Seabrook Station

Seabrook Station, License Renewal Application Relating to the
Alkali-Silica Reaction (ASR) Monitoring Program

**Seabrook Station License Renewal Application
Relating to the Alkali-Silica Reaction (ASR) Monitoring Program
for the Seabrook Station License Renewal Application
Clarifying Information and Response to Requests for Additional Information**

Aging Management Program B.2.1.31.B-*Building Deformation* Element 3-*Parameters Monitored/Inspected* Stage 1: Susceptibility Screening Evaluation (SBK-L-16013 / Enclosure 4 / Page 25) is revised to reflect that a Stage 1 evaluation may progress directly to a Stage 3 Detail Evaluation

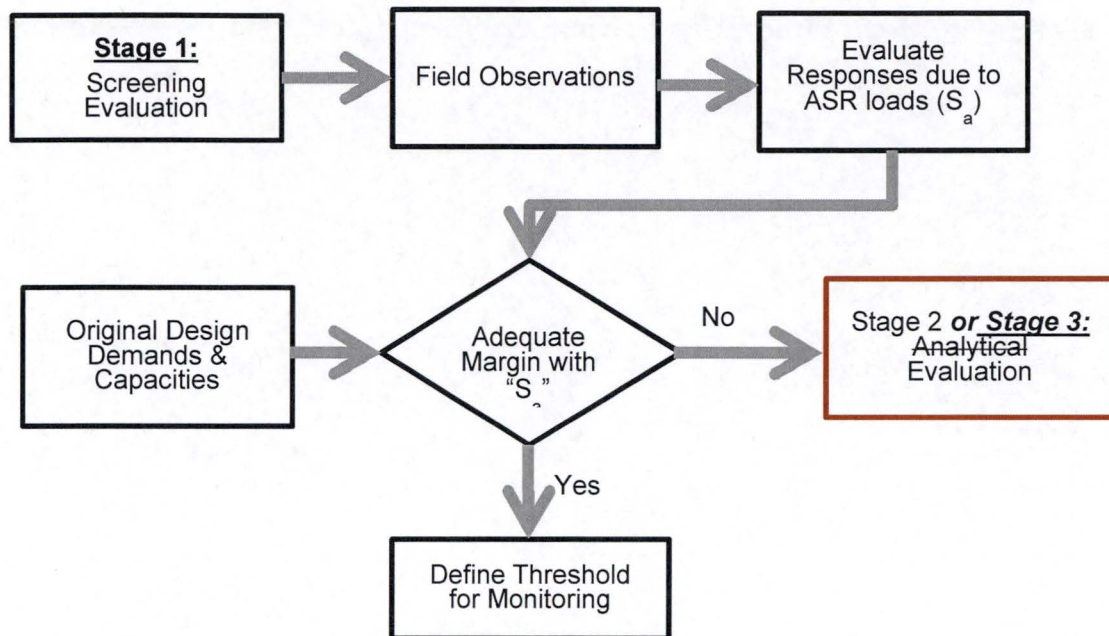
1. NextEra Energy Seabrook stated it needed to clarify that for the Building Deformation program, it does not need to start with a “stage 1” evaluation and that the evaluation for each structure can start at any of the three stages (using a general basis), and if necessary progress to higher stages where necessary. NextEra Energy Seabrook stated it will modify the submittal anywhere (i.e., instances in the submittal) that reads as though a structure must be analyzed at a lower stage before conducting an analysis at a higher stage.

Aging Management Program B.2.1.31.B-*Building Deformation* Element 3-*Parameters Monitored/Inspected* (SBK-L-16013 / Enclosure 4 / Page 22) is revised to include statement regarding the initial selected analysis stage:

A three ~~step~~-*stage* process will be used to initially screen for deformation and to analyze the effects on structures for the self-straining loads from ASR expansion, creep, shrinkage, and swelling. Each stage of the process would have increasing levels of rigor. *The analysis and evaluation of each structure may begin at any of the three stages. If initial review of a structure determines that a structure cannot be qualified in a particular evaluation stage due to high ASR expansion, low margin in the structural design, or any other limitation that excludes the structure from being qualified at that stage, the structure can be evaluated at a higher stage evaluation that employs more rigor. Ultimately the structure is classified according to the stage in which it is qualified to meet the design code requirements and monitored accordingly. For example, a stage 2 structure is qualified using a stage 2 evaluation and thresholds are monitored to stage 2 thresholds.*
